Subject: Response to the Nuclear Regulatory Commission's ("NRC") notice of solicitation of public comments on risk-informed changes to loss-of-coolant accident technical requirements

**MARK EDWARD LEYSE'S RESPONSES TO THE NUCLEAR REGULATORY
COMMISSION'S NOTICE OF SOLICITATION OF PUBLIC COMMENTS ON
RISK-INFORMED CHANGES TO LOSS-OF-COOLANT ACCIDENT
TECHNICAL REQUIREMENTS**

Appendix N Figure 37. Temperatures of the Heated Rods (CORA-13) and Figure 39. Temperatures of the Unheated Rods (CORA-13)²

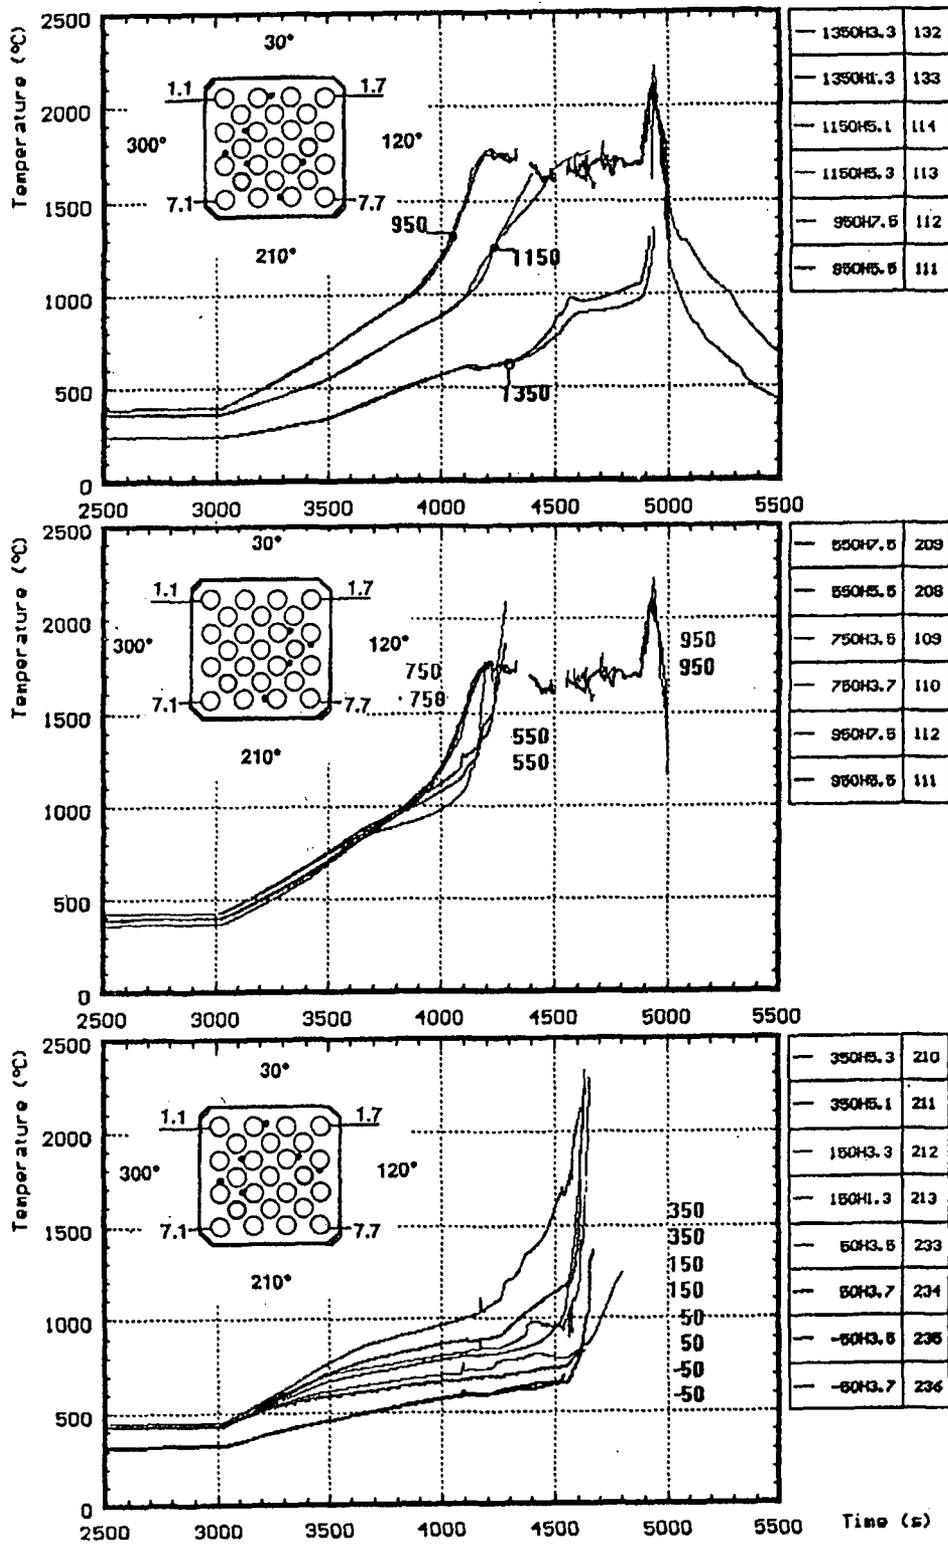
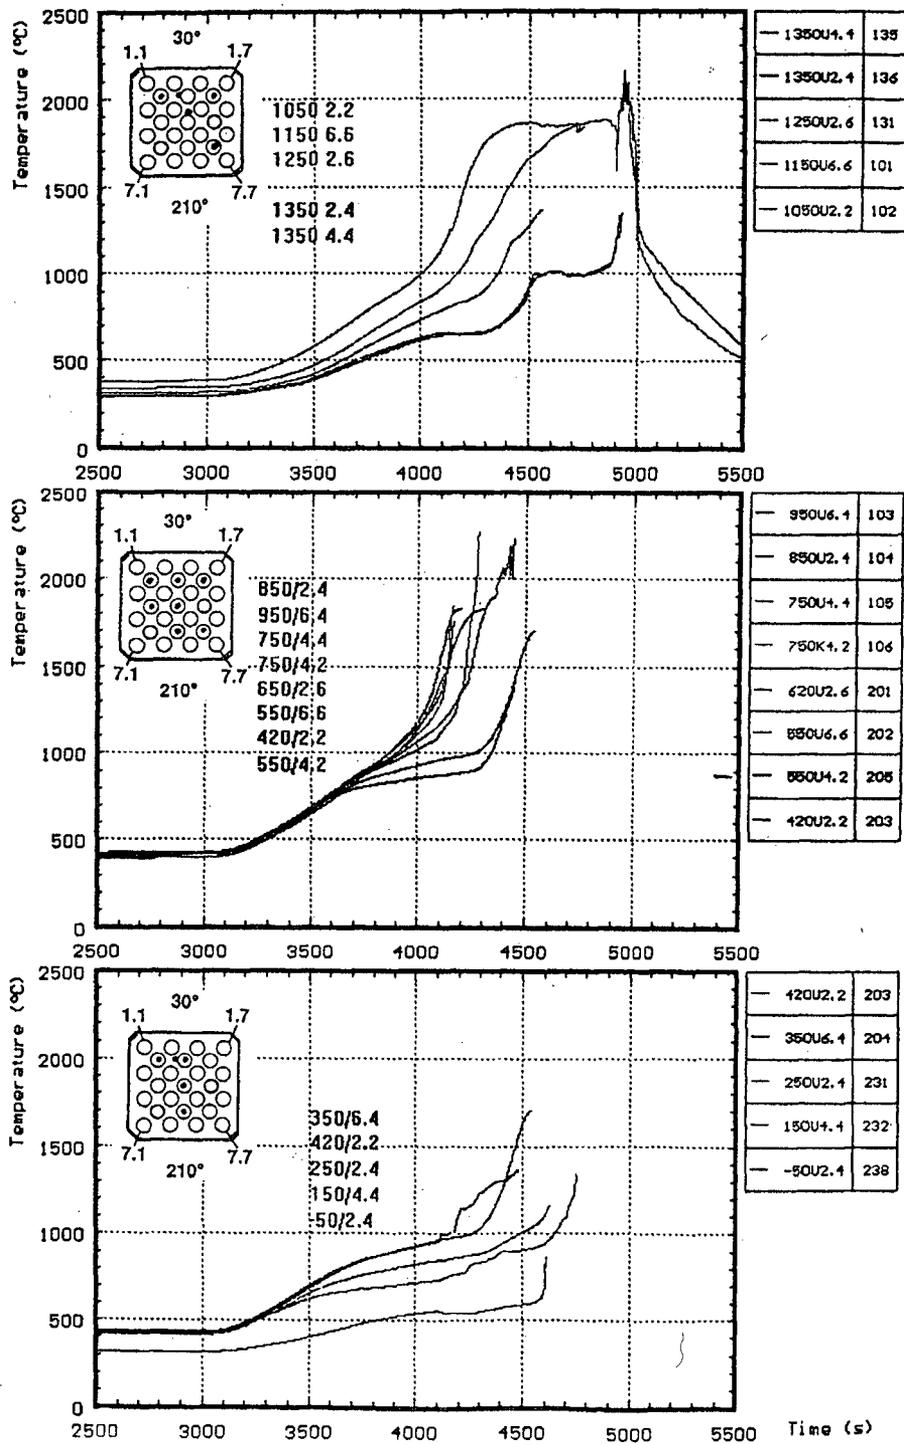
²⁴⁵ See Appendix M Figure 15 Temperatures of Unheated Rods and Power History of CORA-5, Figure 16 Temperatures of Unheated Rods during CORA-12, Figure 17 Temperatures at Different Elevations during CORA-15, Figure 18 Temperatures of Unheated Rods during CORA-9, Figure 19 CORA-7; Temperatures at Elevations Given (750 mm), and Figure 20 Temperatures of Guide Tube and Absorber Rod during Test CORA-5, which depict temperature excursions during various CORA tests; see also Appendix N Figure 37 Temperatures of the Heated Rods (CORA-13) and Figure 39 Temperatures of the Unheated Rods (CORA-13).

Appendix P Figure A8.9. Comparison of Predicted and Measured Thermal Histories for Zr2K Rods with TC Anomalies⁴ and Figure A8.10. Analysis of Zr2K Thermal Response⁵

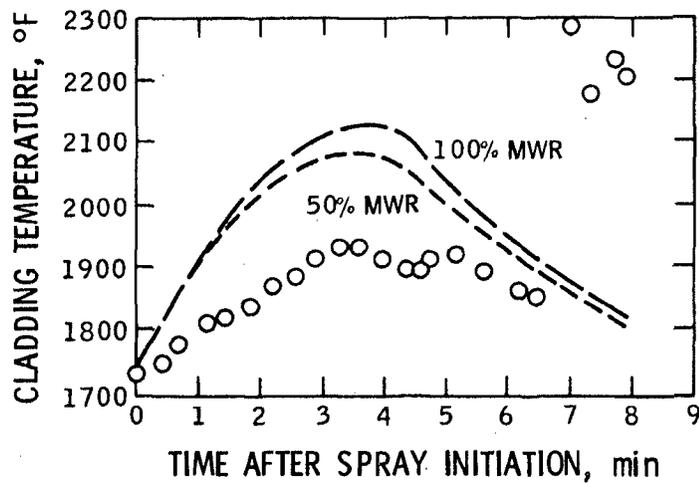
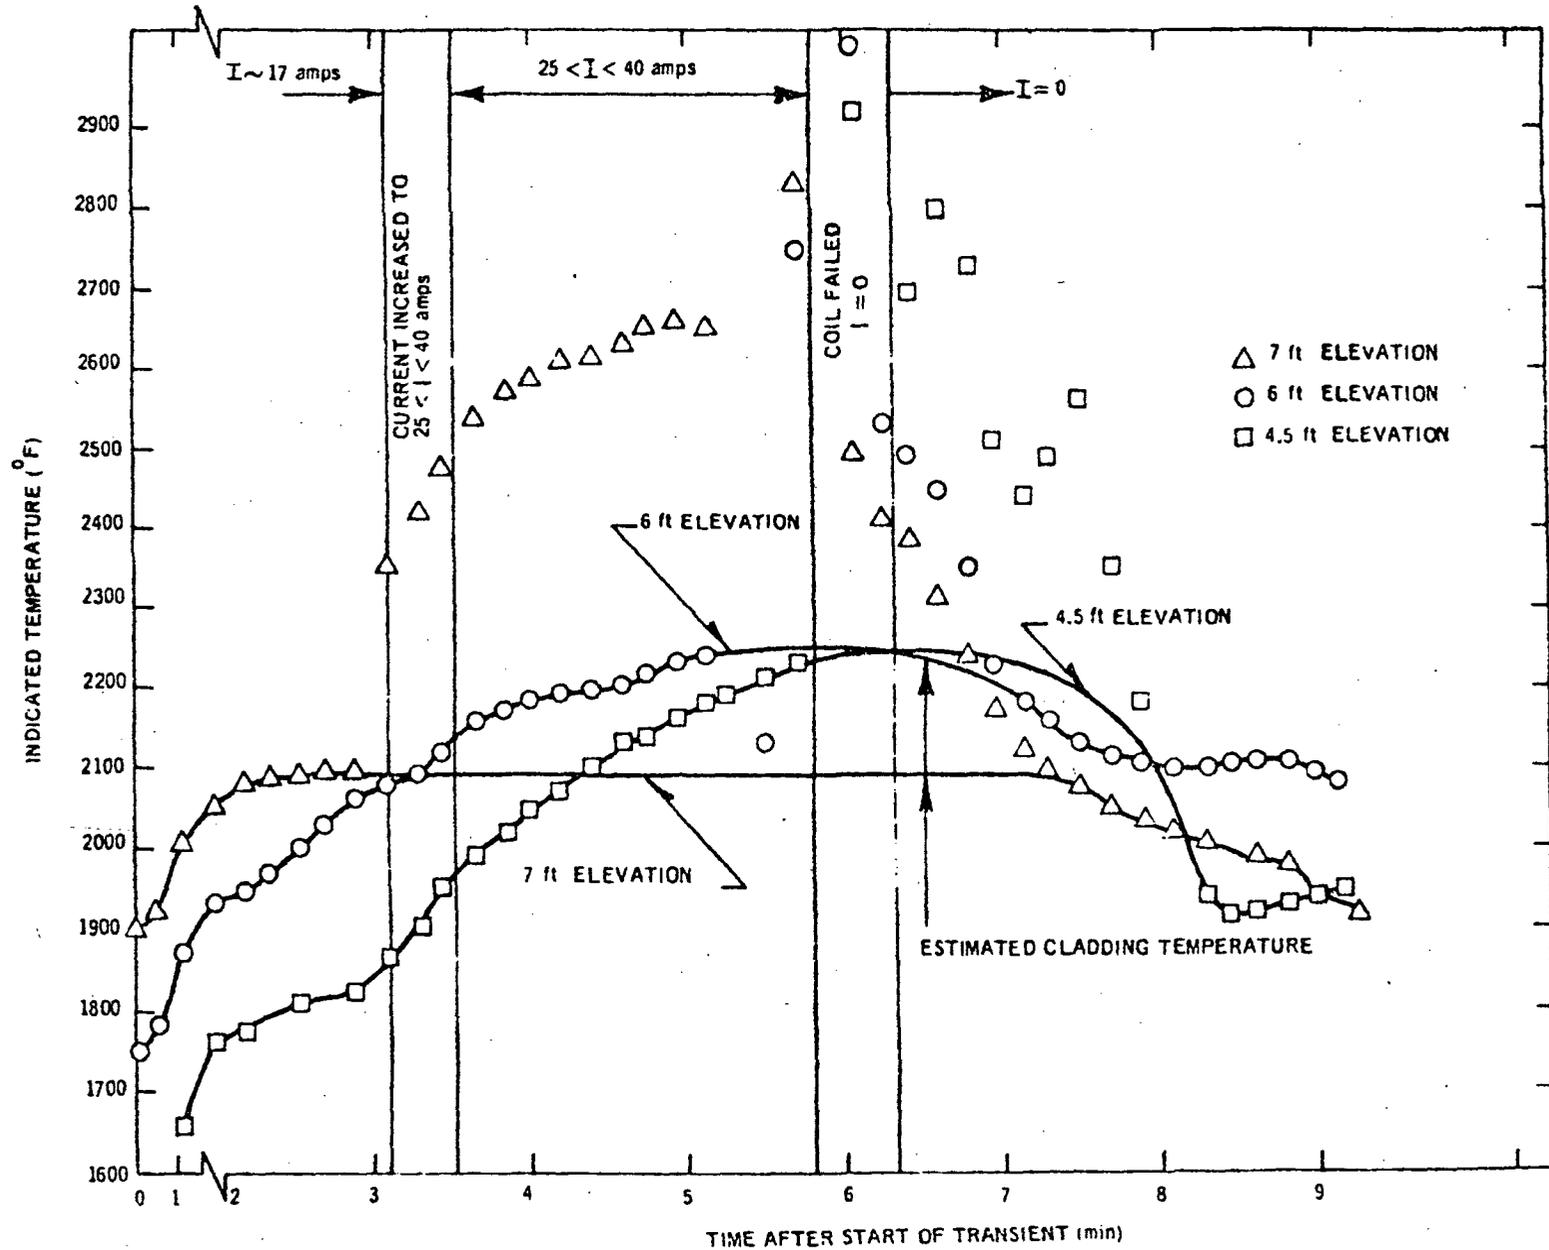
The Zr2K test had cladding-temperature increases of several hundred degrees Fahrenheit within approximately 20 seconds, at some locations of its assembly, after cladding temperatures reached between approximately 2100 and 2200°F (see Appendix P Figure A8.9 Comparison of Predicted and Measured Thermal Histories for Zr2K Rods with TC Anomalies and Figure A8.10 Analysis of Zr2K Thermal Response).
